PREBID CLARIFICATION

I-HUB QUANTUM TECHNOLOGY FOUNDATION, IISER, PUNE

Refer I-HUB QTF's GeM tender no. GEM/2023/B/3724947 dated 05/08/2023 with file reference no. I-HUBQTF/PUR/23-24/010 for the procurement of Inductively Coupled Plasma-Reactive Ion Etching (ICP-RIE). The Pre-Bid meeting was held on 16/08/2023.

TECHNICAL AND COMMERCIAL QUERIES AND CLARIFICATION – ANNEXURE I

Etch test -1

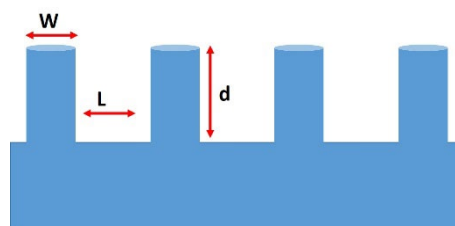
Nano-pillar on Silicon (as shown in the adjacent schematic): Pattern with Al₂O₃, SiO₂, Al, mask will be supplied by IISER Pune.

1. Min/Max for W = 20-500nm, L=30nm-1000 nm, d= 500nm-10 um
2. Pillar side wall 86-90 degree

3. W/d (aspect) ratio = 1:50 or better
4. RMS roughness for the flat area <3 nm
5. Max. allowed std. deviation <5%

Etch test -2

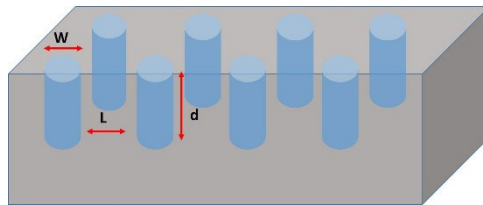
Array of nano-hole on Silicon/SiNx (as shown in the adjacent schematic): Pattern with Al₂O₃, SiO₂, Al, mask will be supplied by IISER Pune.

1. Min/Max for W = 20 nm- 3 μm, L = 30nm- 5 μm, d = 400nm-10 μm
2. Hole inner wall should be vertical (within 86-90 degree)
3. W/d W/d (aspect) ratio = 1:20 or better
4. RMS roughness for the flat area <5 nm

Same structure on SiO₂ needs to be etched to achieve the following parameter

1. Min/Max for W = 200 nm- 2μm, L = 300nm- 3μm, d = 200nm-500 nm
2. Side wall angle 90±5 degrees
3. W/d W/d (aspect) ratio = 1:10 or better
4. RMS roughness for the flat area <5 nm
